TO: District of Columbia Zoning Commission
FROM: Jennifer Steingasser, Deputy Director- Development Review & Historic Preservation
DATE: October 19, 2012
SUBJECT: Setdown Report – ZC 05-36G – Modification to PUD in Square 749

Figure 1. Approved and Proposed PUD Phases, with zoning that underlies C-3-C zoning of existing PUD

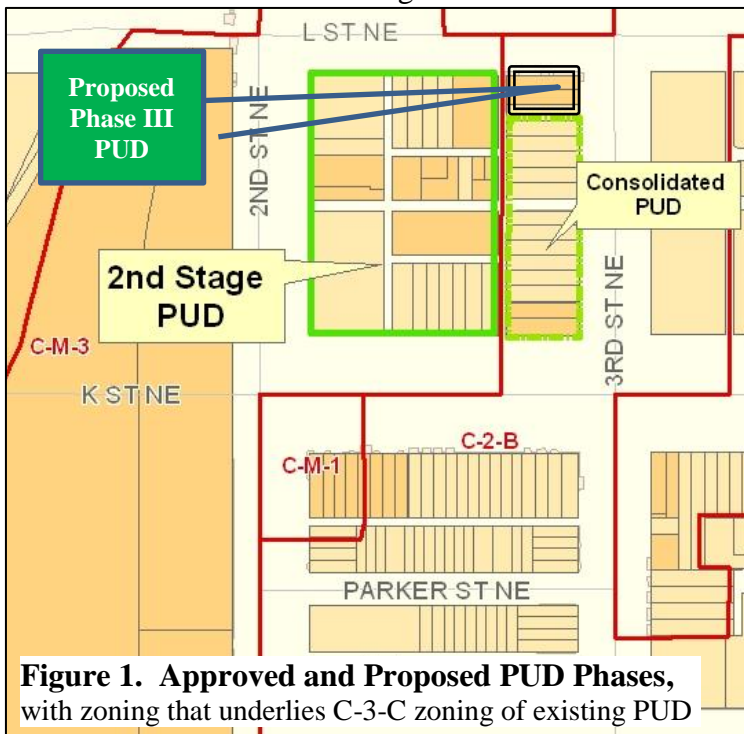
The present proposal would add the remaining three lots in the Square to the PUD. These would contain a seven story approximately 41-unit all-residential building. It would be joined below-grade to the Consolidated PUD in order to share the existing garage and other PUD amenities. The applicant asks that the three C-2-C zoned lots be granted the same related C-3-C zoning as the rest of the PUD.
